Donald C. Cook Nuclear Plant Unit 2
Proposed Alternative to the
American Society of Mechanical Engineers Code, Section XI
Repair Requirements

10 CFR 50.55a Relief Request Number ISIR-4-06

**Proposed Alternative in Accordance with 10 CFR 50.55a(a)(3)(ii)
Hardship or Unusual Difficulty without Compensating Increase in
Level of Quality or Safety**

Proposed Overlay

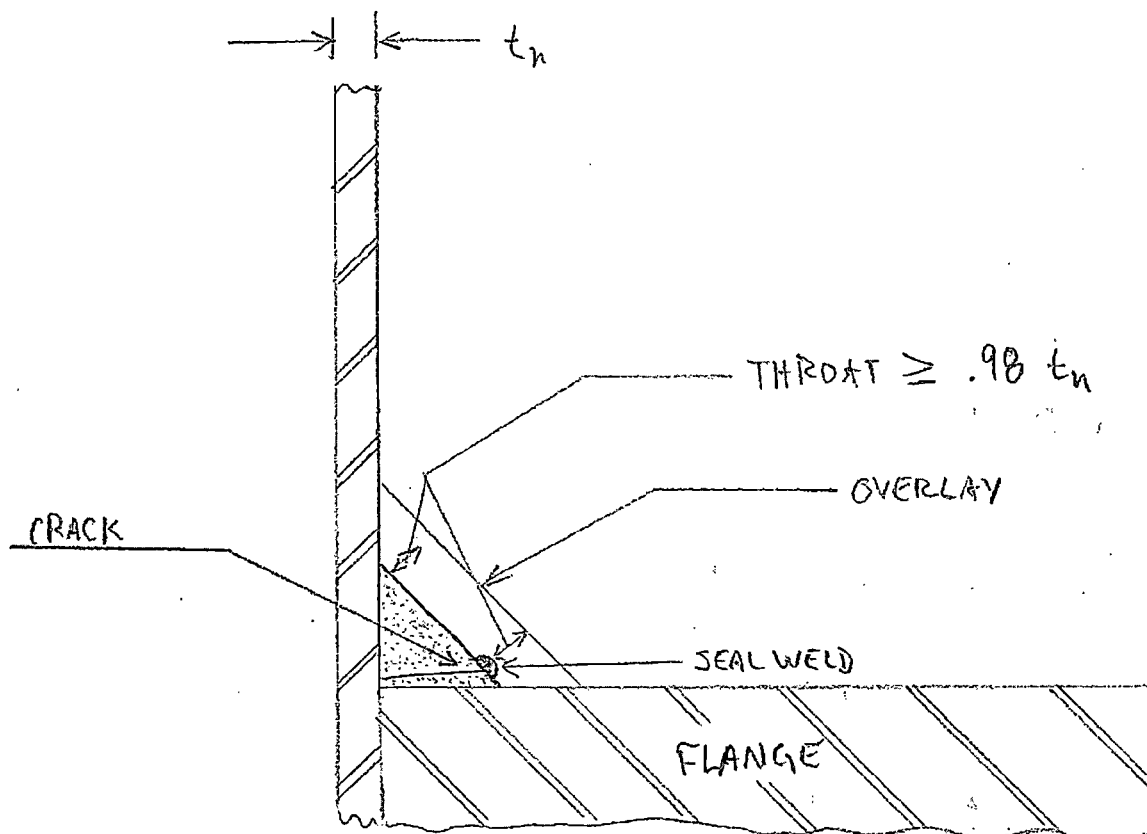
- The through wall defect is on the toe flange side of the weld which most likely propagated from the root of the weld.
- A sketch of the pipe, flange, existing weld and overlay, and an isometric drawing marked to show the flange with the leak are provided in Section 7 of this attachment.
- The flange and pipe material are listed in the following table.

The leak will first be seal welded with 309L filler material. The seal weld will be examined visually (VT-1) and dye penetrant tested prior to performing the weld overlay.

The seal weld will be examined by VT-1 and a penetrant test (PT) of the seal weld.

The overlay will be examined by a PT and a VT-1.
